SSS-269

27 June 1966

Subject: Changes to SS-MOL-1 Integrated, 29 April 1966

SUGGESTED CHANGES TO SS-MOL-1 INTEGRATED

FIGURE 3-5 OPTICAL SENSOR BASIC CONFIGURATION

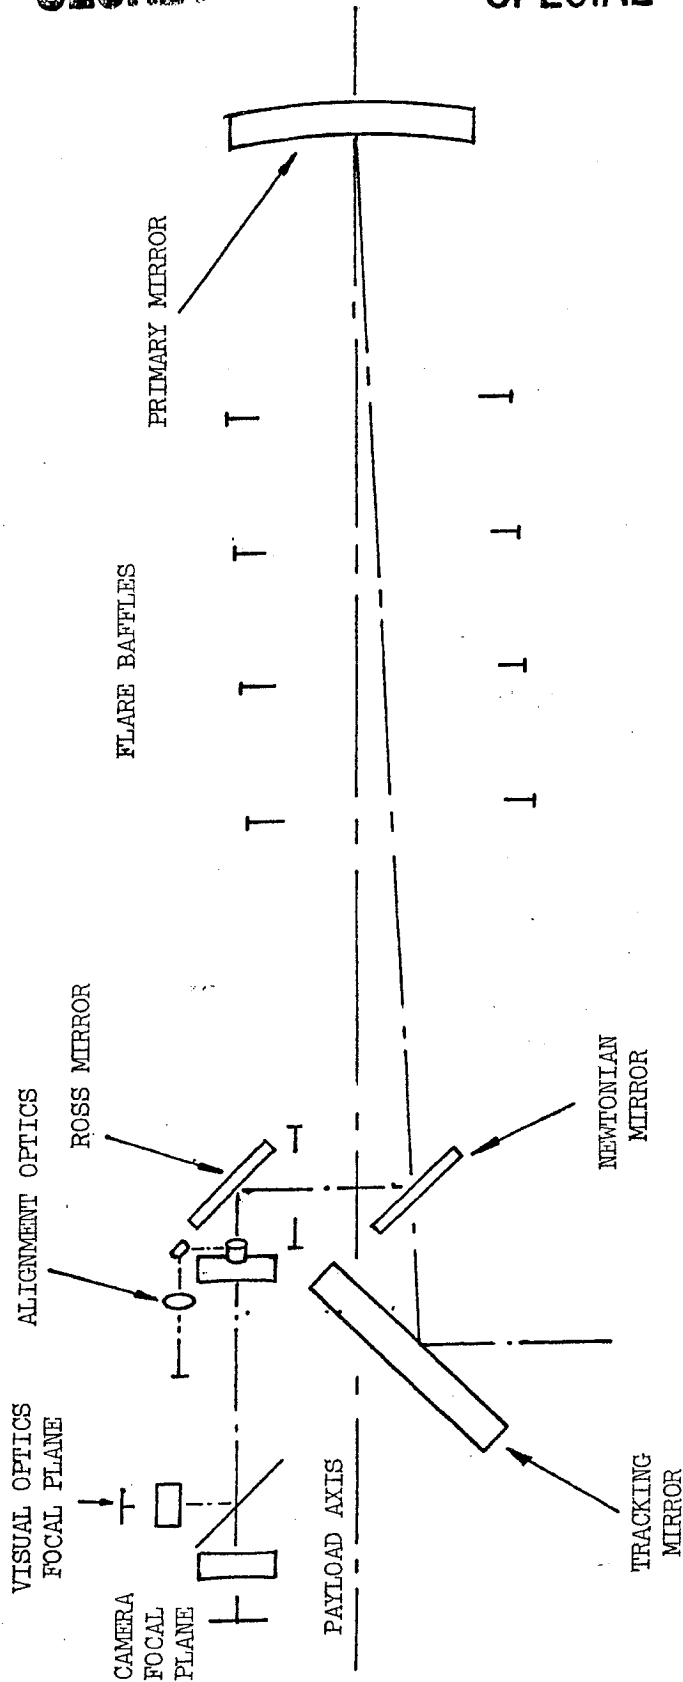
The optical system of the Payload (see figure 3-5), shall consist of a 70 inch aperture, [REDACTED] focal length Ross telephoto lens having a 0.54° semi-field angle. The optical axis shall be approximately parallel to the longitudinal axis of the Mission Module. The Ross corrector assembly shall be above and approximately parallel to the optical axis of the primary mirror.

FIGURE 3-7.

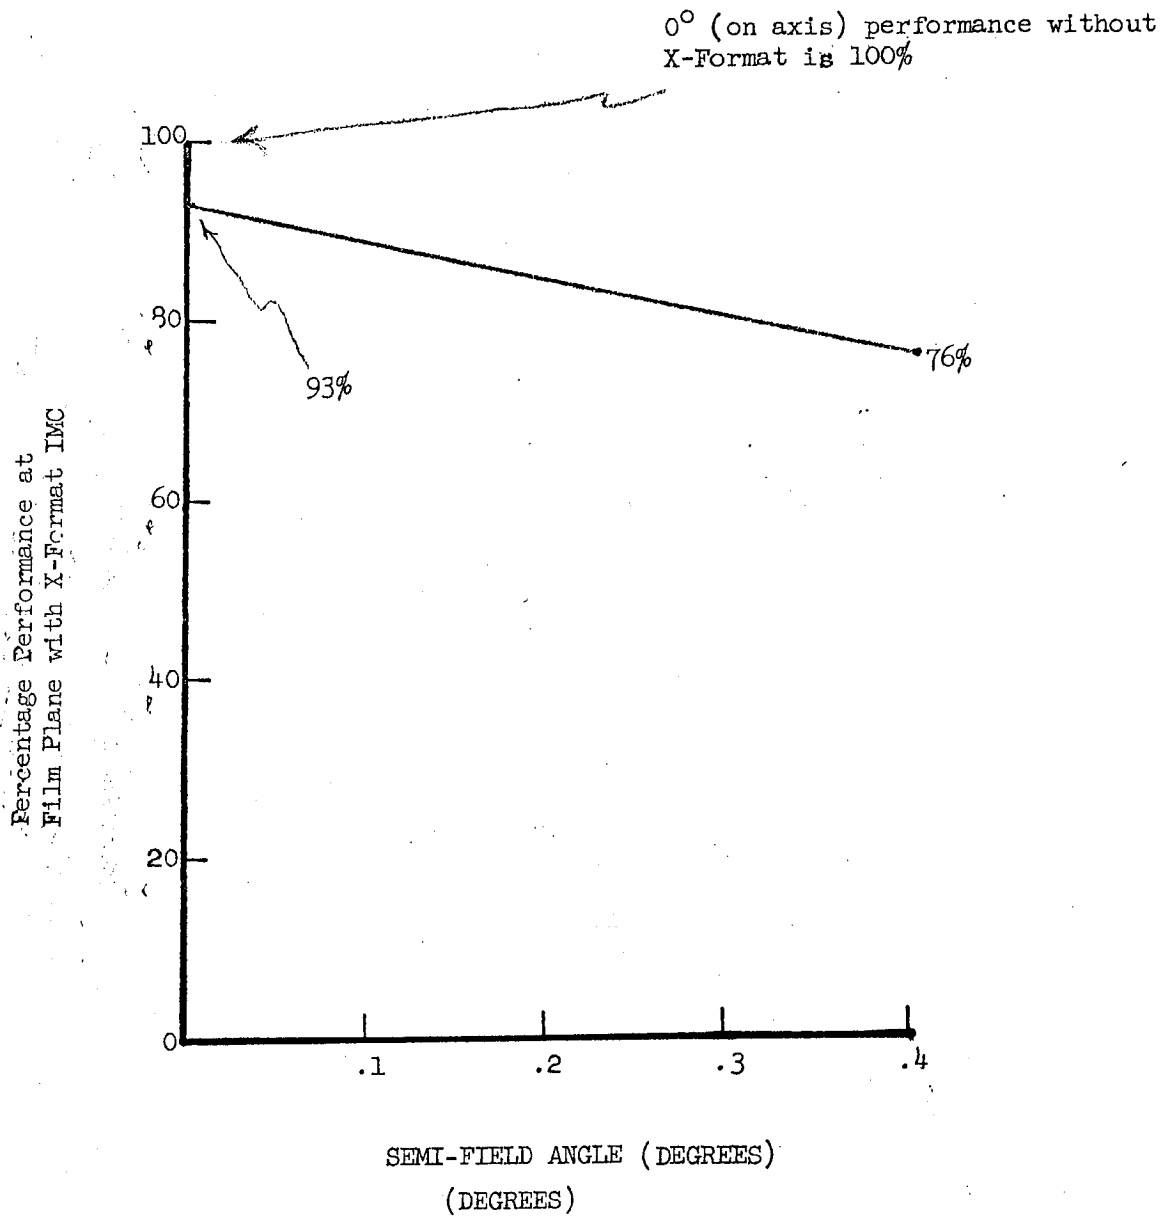
Across-the-format IMC shall be provided which, when used, shall insure that the average geometric mean performance at the film plane anywhere within a 0.8° diameter circle about the center of the format will be greater than that given by Figure 3-7. Across-the-format IMC shall be used only for the primary record.
